## Customer Notification

# VR4181<sup>TM</sup>

## 64-/32-Bit Microprocessor

## Operating Precautions

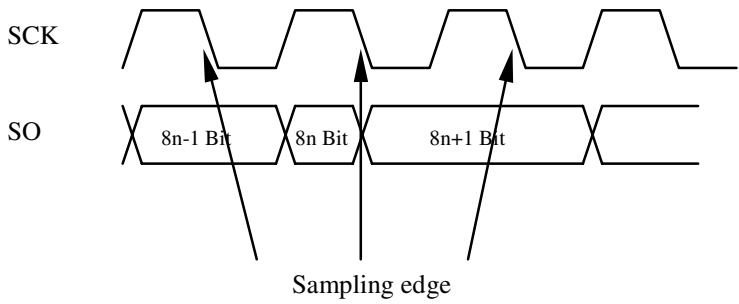
No. 3	Mode register setting for 64 Mbits SDRAM (Specification change notice)
	<p><u>Details</u></p> <p>During the 64 Mbits SDRAM mode register write, A13 of the address bus is forced to logic "1". It should be set logic "0".</p> <p>During the 16 Mbits SDRAM mode register write, A13 had forced to logic "0". Use following sequence to initialize 64 SDRAM:</p> <ol style="list-style-type: none"> <li>(1) Set B0Config and B1Config bits of MEMCFG_REG(0x0A000304) register to "01"</li> <li>(2) Initialize SDRAM by setting Init bit of MEMCFG_REG to "1"</li> <li>(3) Set B0Config and B1Config bits to "10" before using SDRAM.</li> </ol>
